ADDENDUM NO. 3

EXETER, NEW HAMPSHIRE

CONTRACT NO. 1 – WASTEWATER TREATMENT FACILITY UPGRADES

FEBRUARY 2017

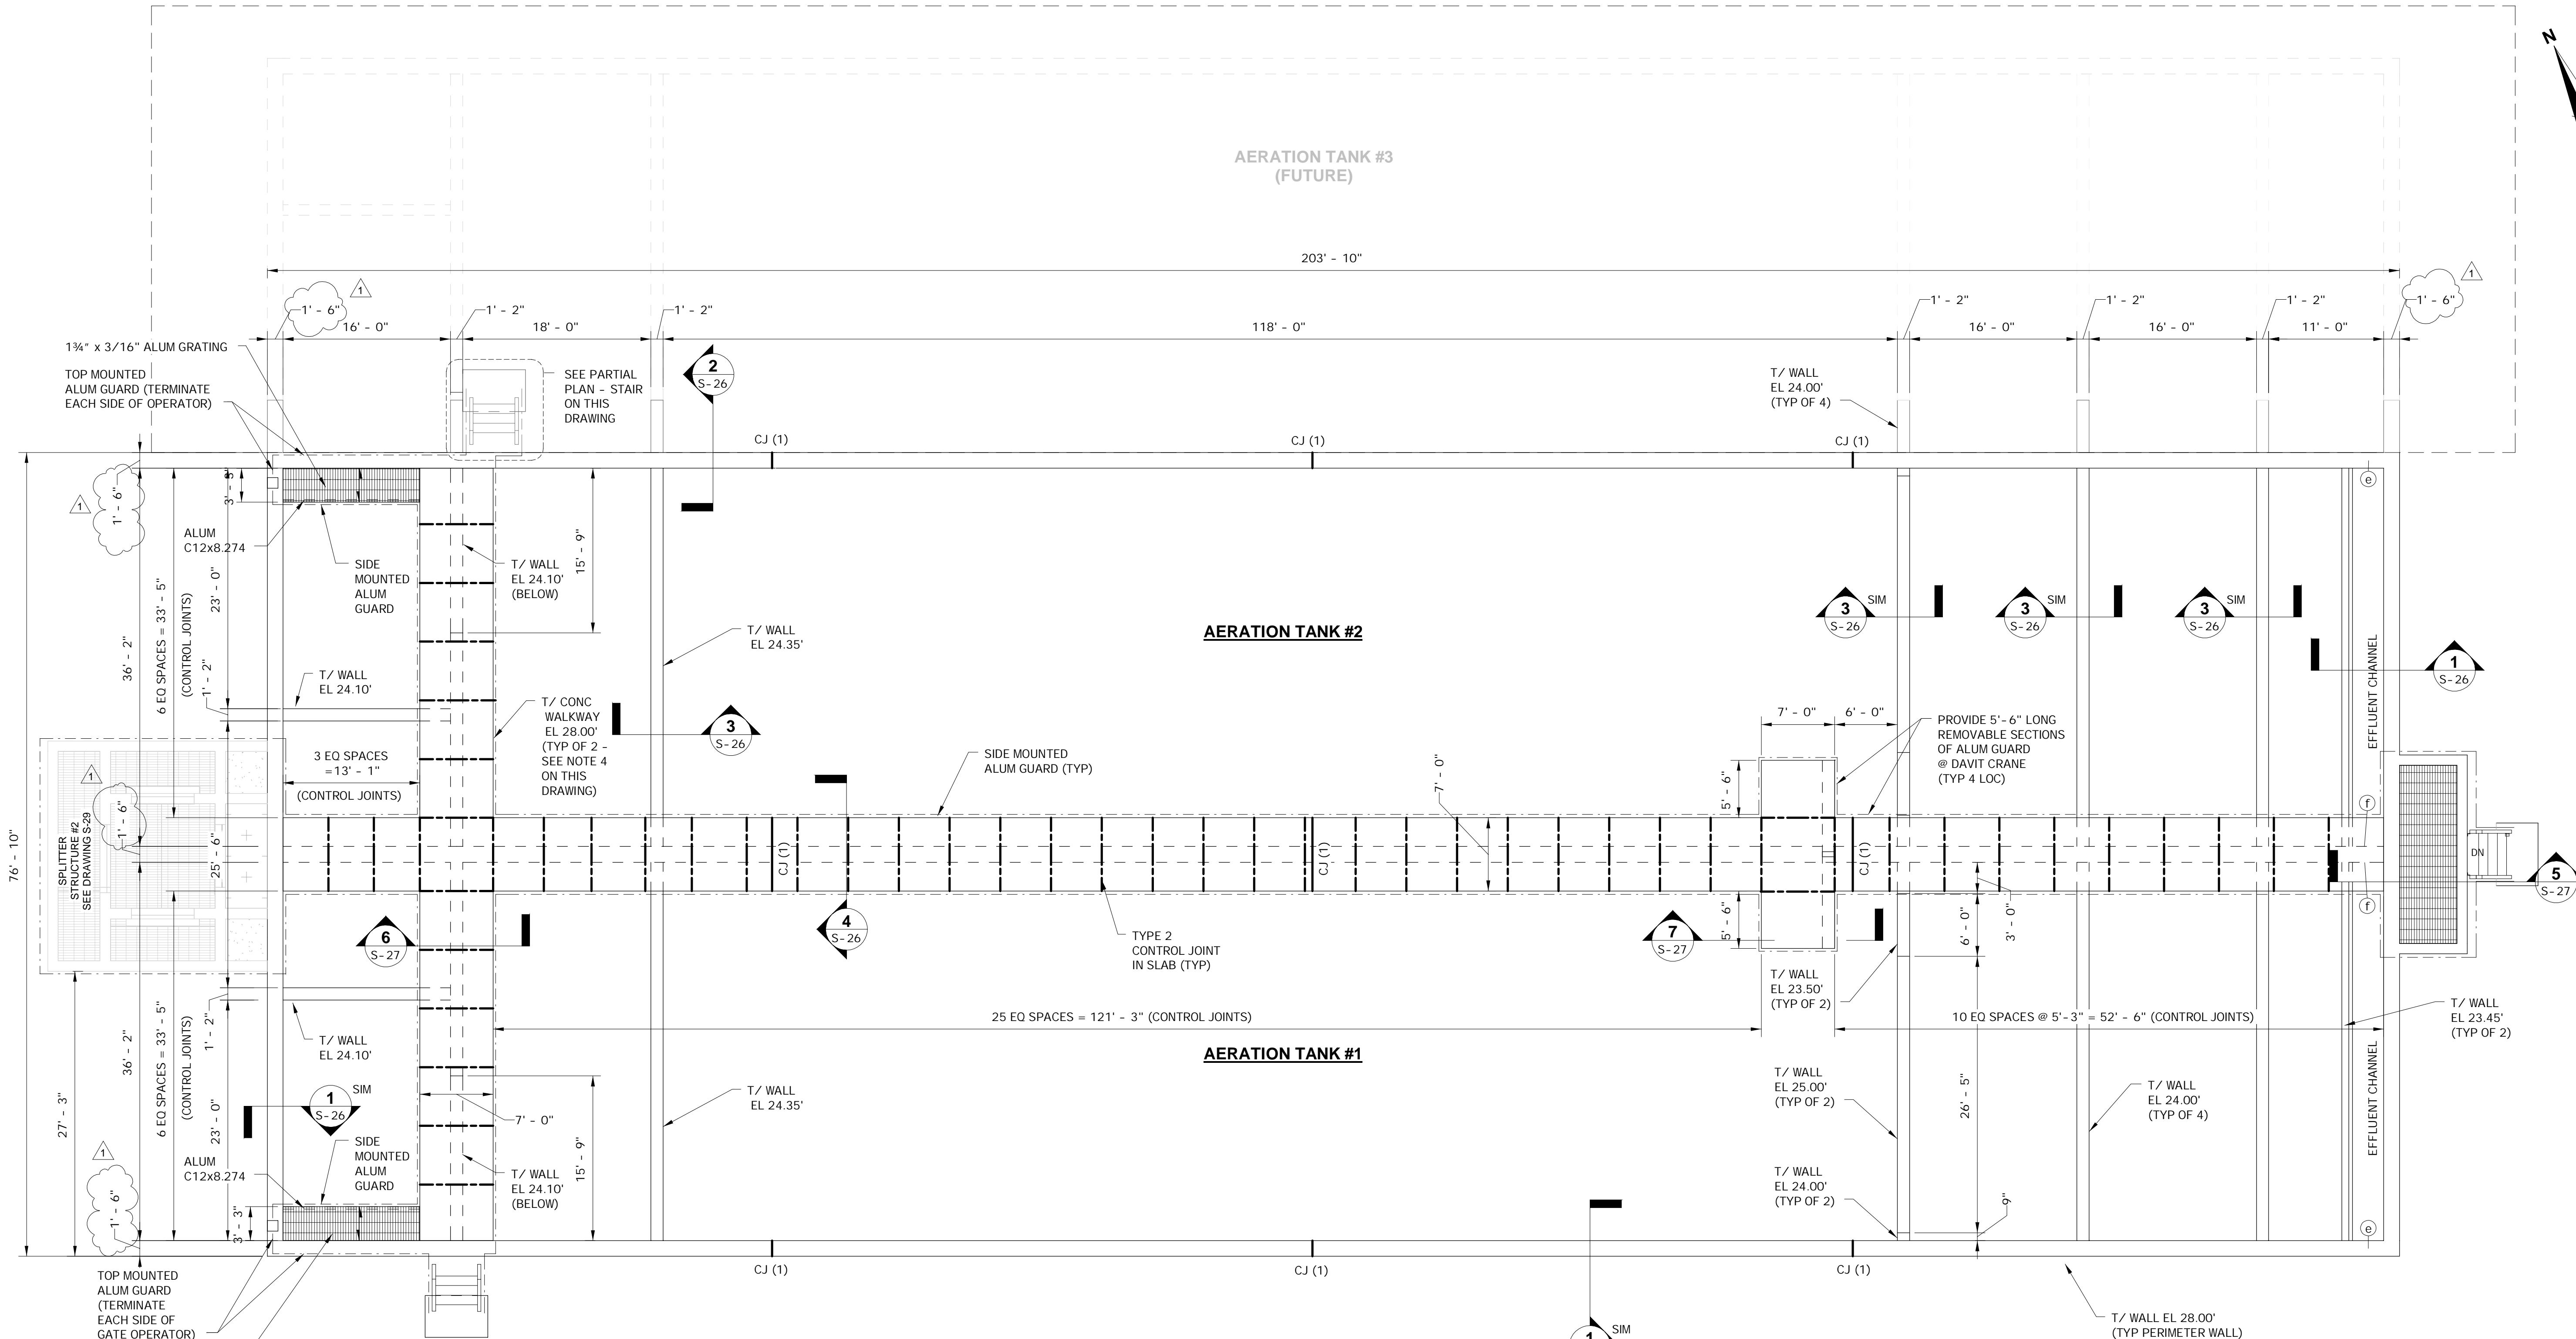
7. Drawing S-24, Aeration Tanks. **DELETE** the drawing and **REPLACE** with the attached version.
8. Drawing S-25, Aeration Tanks. **DELETE** the drawing and **REPLACE** with the attached version.
